North Eastern Indira Gandhi Regional Institute of Health and Medical Sciences
(An Autonomous Institute, Ministry of Health and Family Welfare, Government of India)
Director's Block, Mawdiangdiang, Shillong 793 018 (Meghalaya)

Tender Amendment No: NEIGR/S&P/12/01/2019 -20

e-TENDER AMENDMENT

Reference Tender Enquiry No: NEIGR/S&P/OT/E –47/2019-20 for Setting up of Catheterization Laboratory /Cath Lab with Digital Subtraction Angiography Equipments, with detailed turkey works including electrical panels, wiring against buy back of old existing obsolete Mobile Cath Lab with DSA (Make: Allengers Medical Systems Ltd.; Model: Allengers Life; Year: 2008)

Proposed plan for Cath lab (Shaded Area)

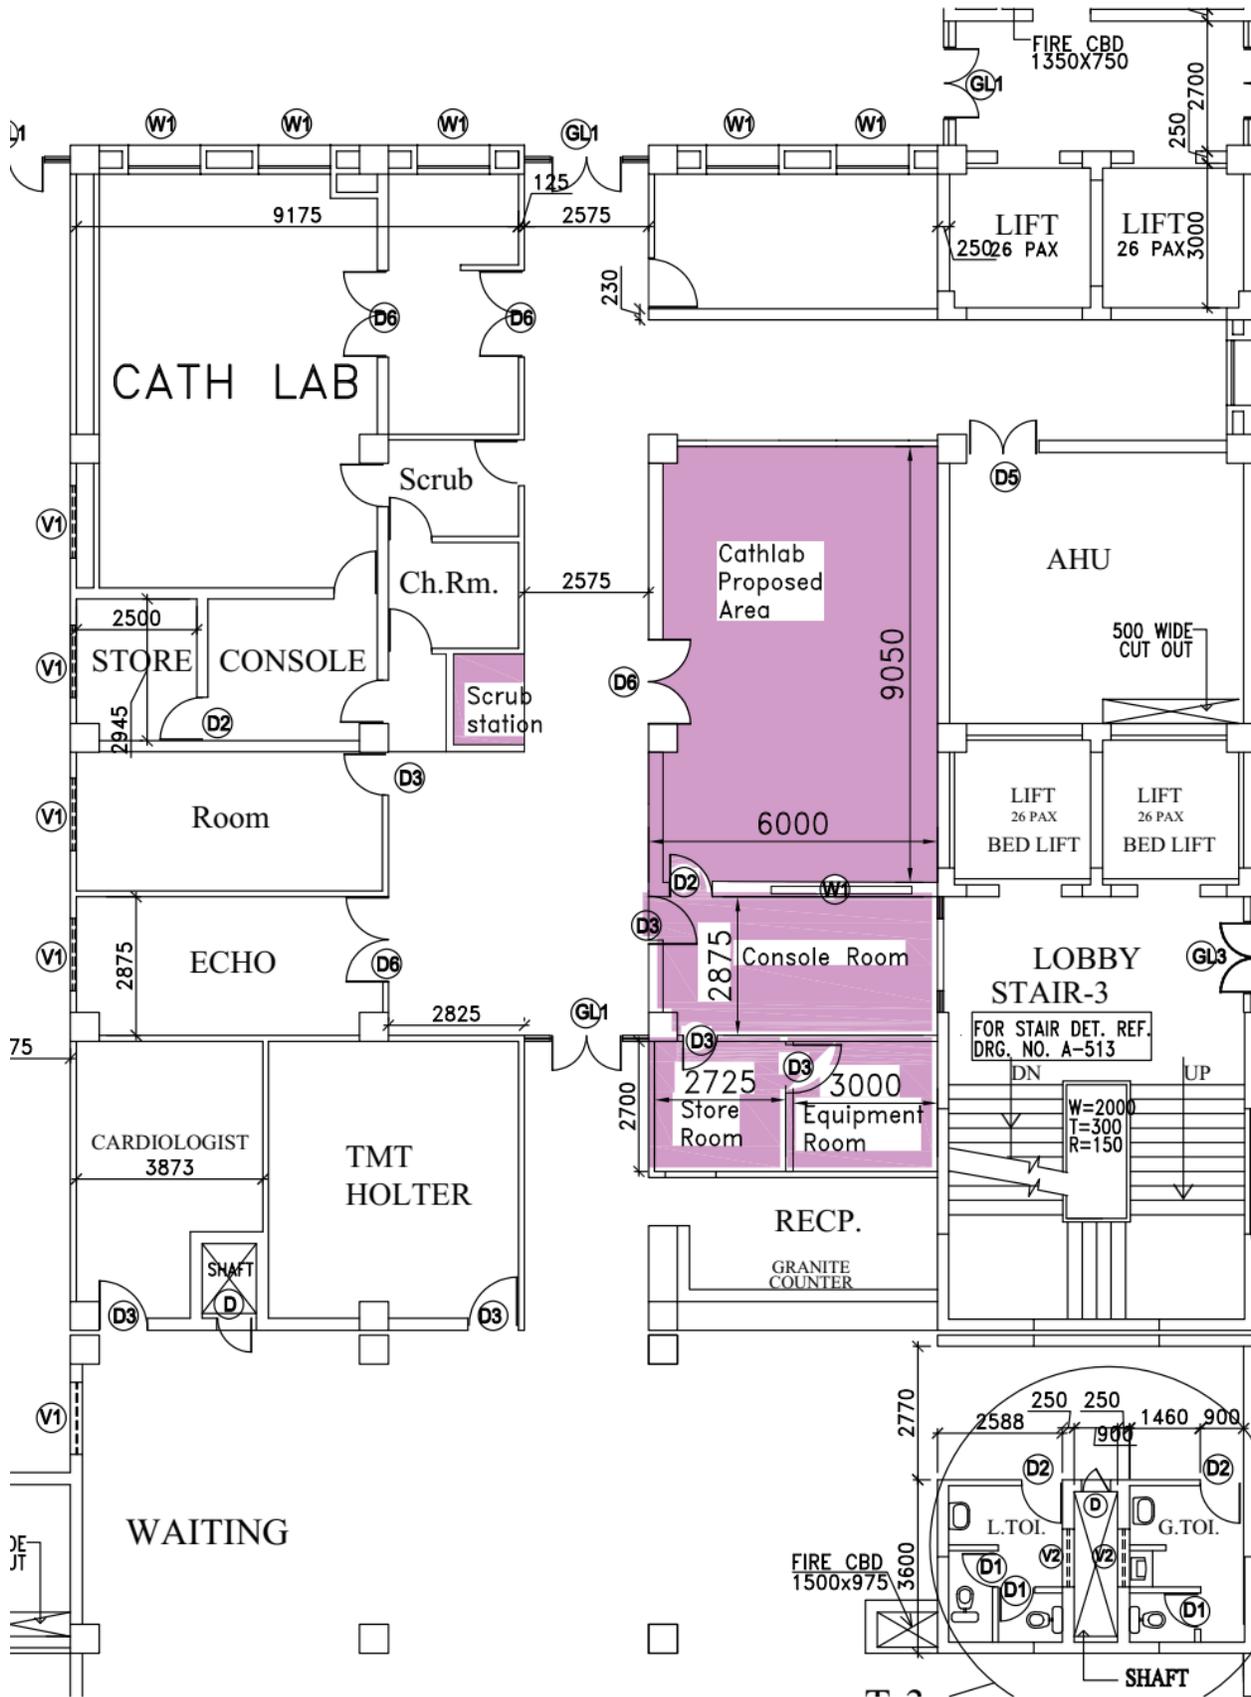
25.1.1.1	Additional point:	Flush mounted full length wardrobe with glass doors (3 nos) must be supplied to keep the stents & catheters etc materials inside the lab. The Doors (D6 & D2) mentioned in the drawing must be sliding type (SS/HPL) with lead lining& viewing window as per the AERB guideline ,W1 will be lead glass viewing window .
	Electrical work should consist of point wiring in all rooms, using copper wiring, sockets & switches (renowned make like Finolex, Havells, V-Guard etc. or equivalent) Cable trench and trays should be provided.	<ul style="list-style-type: none"> Electrical work should consist of point wiring in all rooms, using copper wiring, sockets & switches Electrical Panel (renowned make like Finolex, Havells, V-Guard etc. or equivalent) Cable trench and trays should be provided. The cable length from DG Panel to UPS room (Ground Floor) to Cathlab(1st floor) will be 70 m \pm15% (approx.) . The cable size must be 3.5 x 185 sq mm.
